CPED STAFF REPORT

CPC Agenda Item #7
July 14, 2014
BZZ-6616

Property Location: 300 South 2nd Street
Project Name: Mill City Quarter Phase I
Prepared By: [Janelle Widmeier](#), Senior City Planner, (612) 673-3156
Applicant: Mill City Quarter LLC
Project Contact: Gretchen Camp, BKV Group Inc.
Request: To allow a new 6-story, mixed use building with ground floor retail and 150 dwelling units.

1 LANDSCAPE PLAN
1/20"=1'-0"

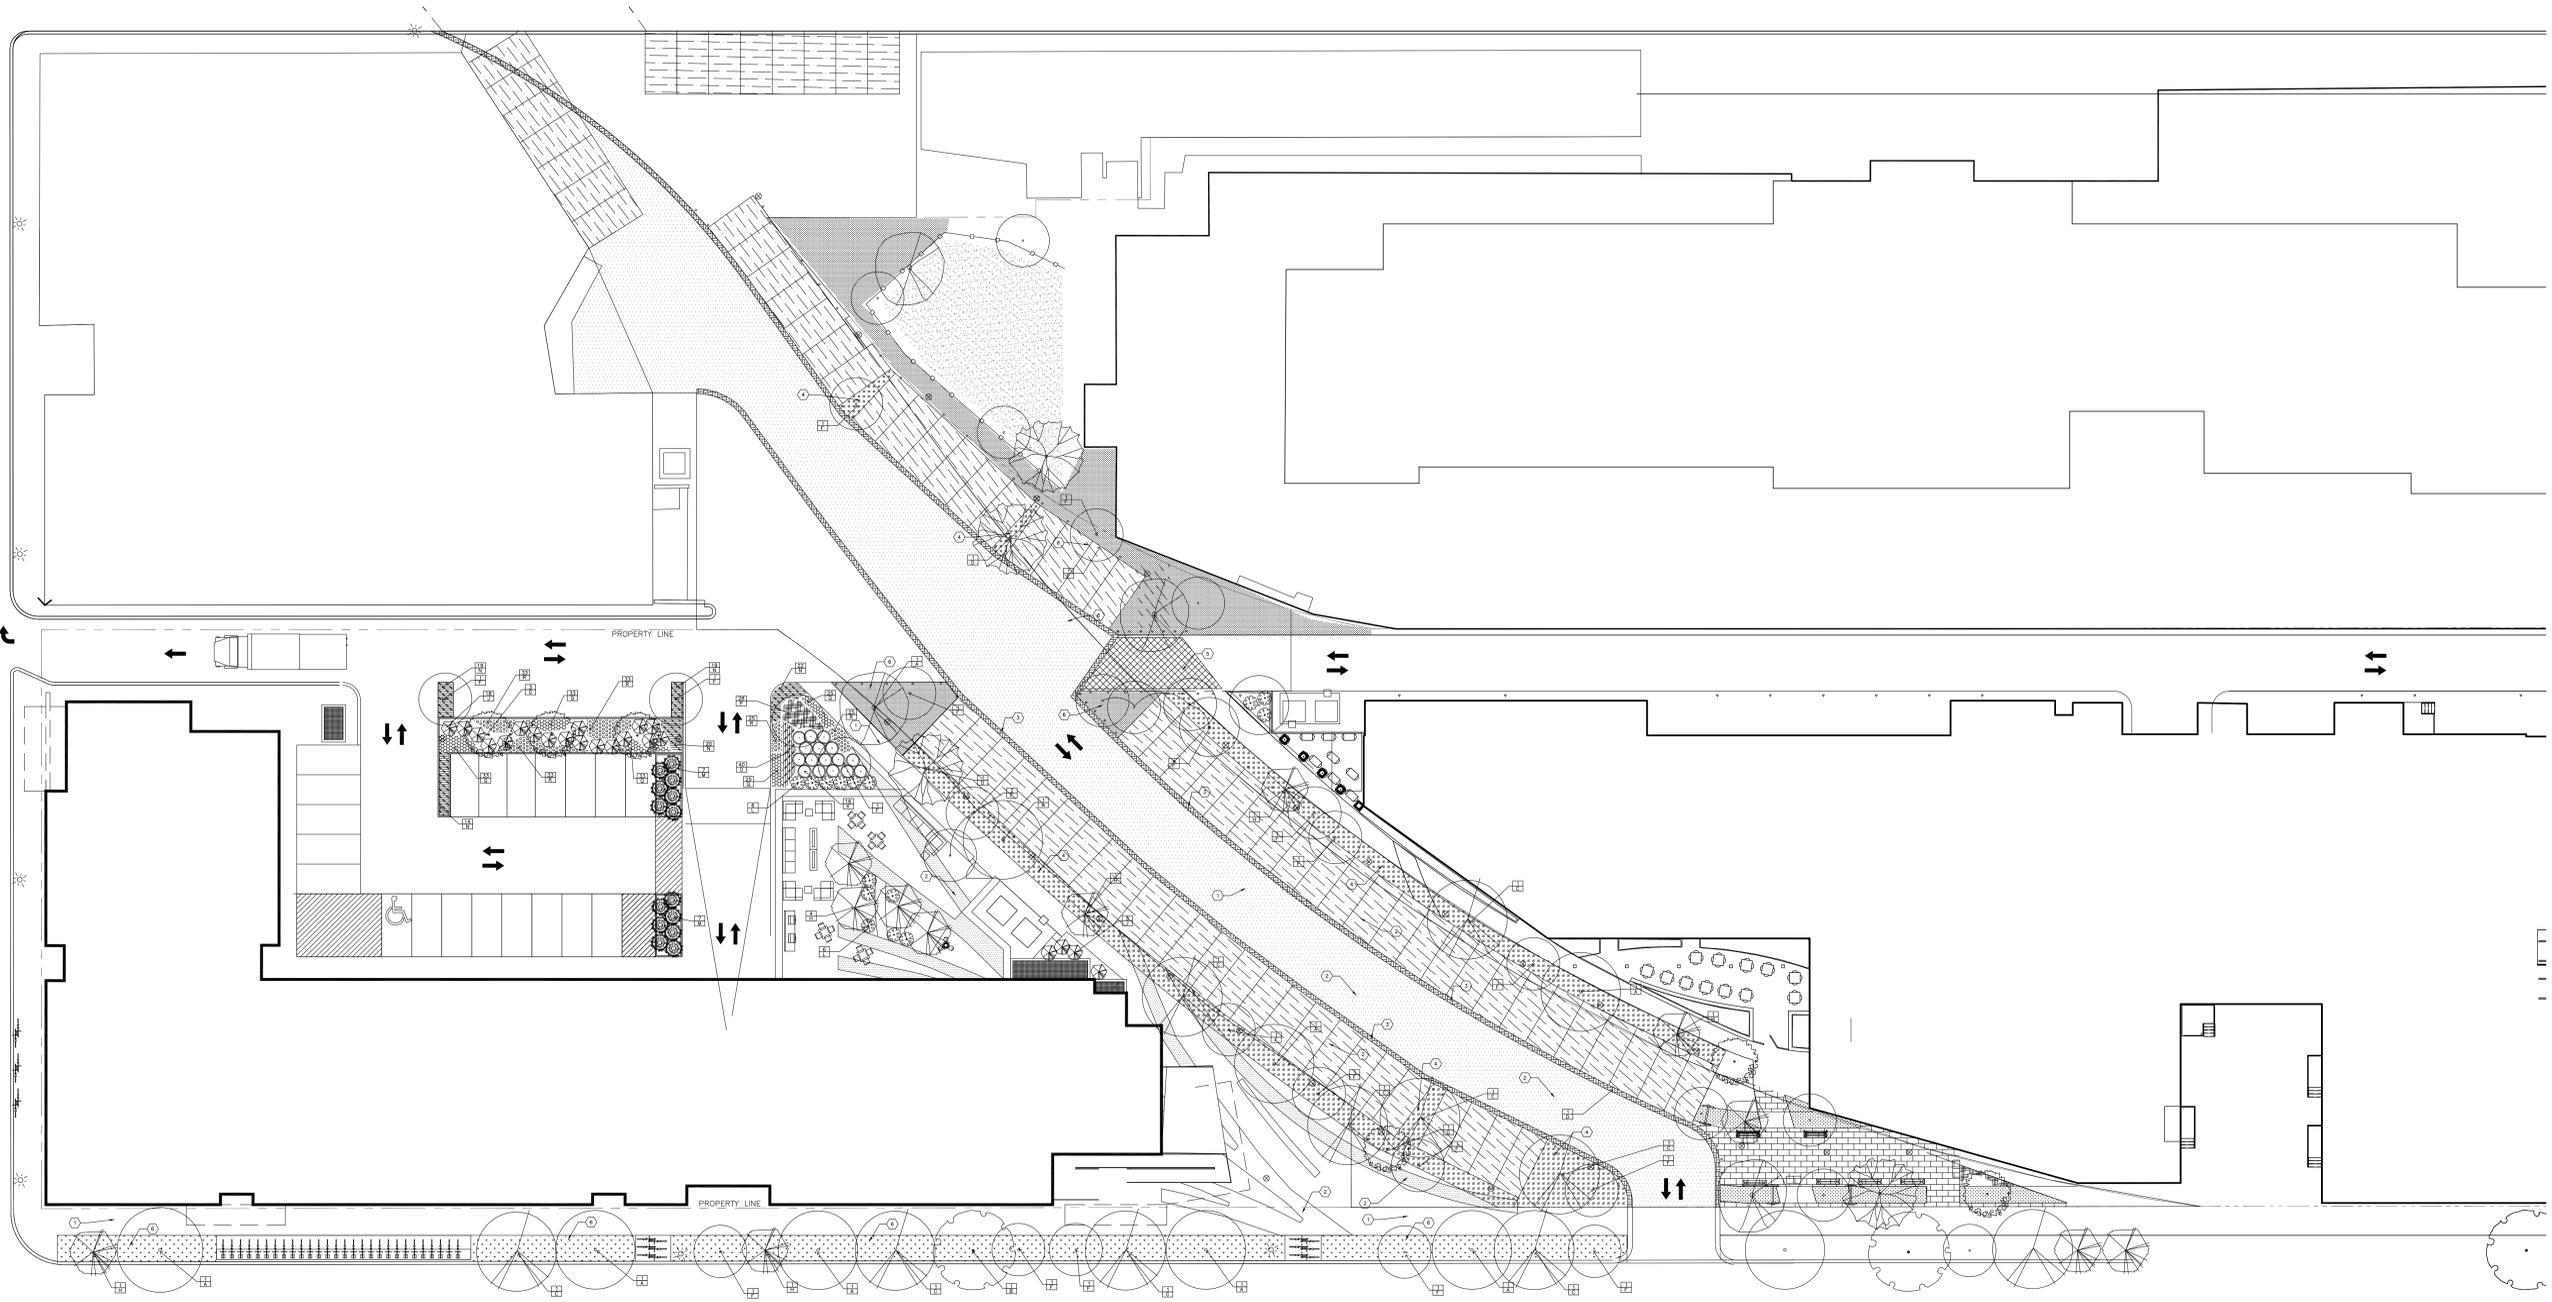
- The proposed tree island would be 9 feet wide. However, not all parking spaces will be within 50 feet of an on-site deciduous tree. Alternative compliance is requested.

- Information is not provided on the landscape plan regarding the installation and maintenance of all landscape materials. Installation and maintenance will need to comply with section 530.210 of the zoning code.

- **Distance to Trees.** Not all parking spaces are within 50 feet of an on-site deciduous tree. Two spaces, in the southwest corner of the parking lot, would not meet this requirement. The surface parking lot is located at the interior of the site over the below-grade garage. It would also be sheltered and shaded by the building most of the day. For these reasons, staff is recommending that the planning commission grant alternative compliance.

1 SITE PLAN
A010 1/16"=1'-0"

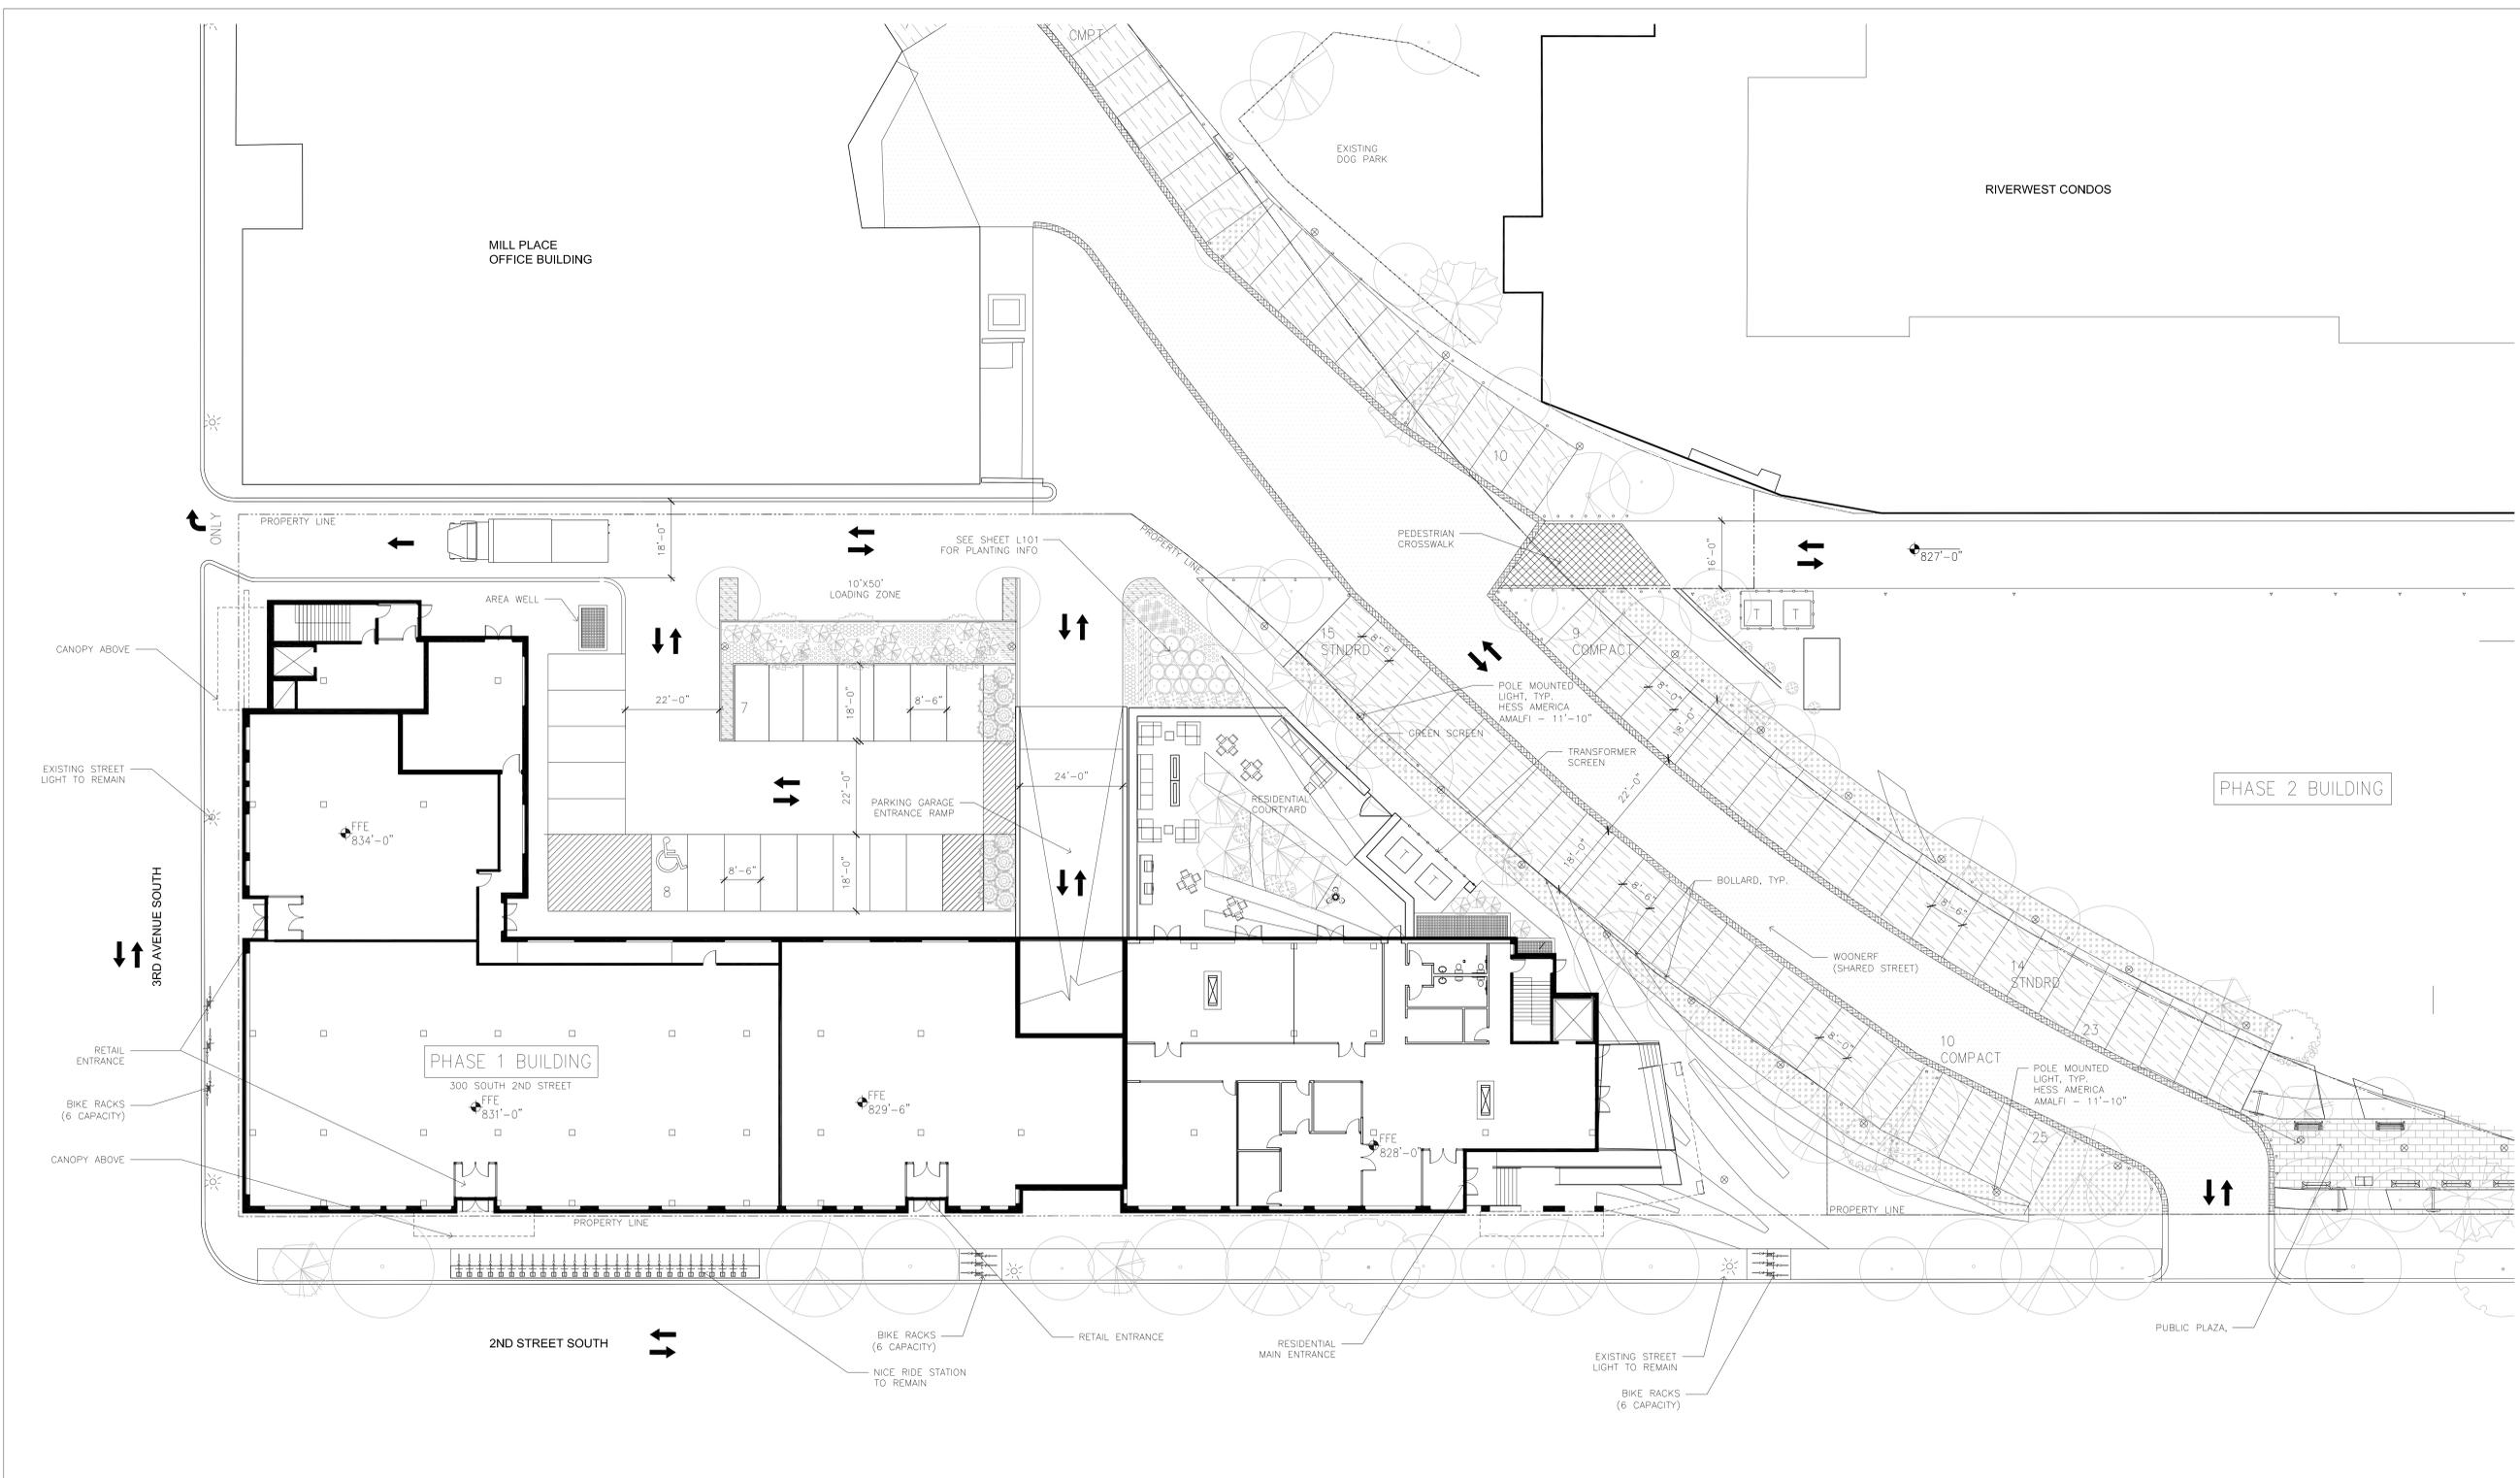
- The site plan (Sheet A010) identifies a canopy overhanging the Public right-of-way along 3rd Ave. S. and appears to indicate a bus shelter (a transit stop does not exist at this location). Metro Transit has been contacted and is not currently aware nor advocating a bus reroute that would accommodate this proposed location; any proposed transit stop at this location shall be fully reviewed and approved by both the Traffic Department and Metro-Transit. All Metro Transit Bus Stops shall be clearly identified on the site plans; and changes proposed bus stop changes shall be coordinated with Metro- Transit, please contact Maurice Roers at (612) 349-7684 for further information.
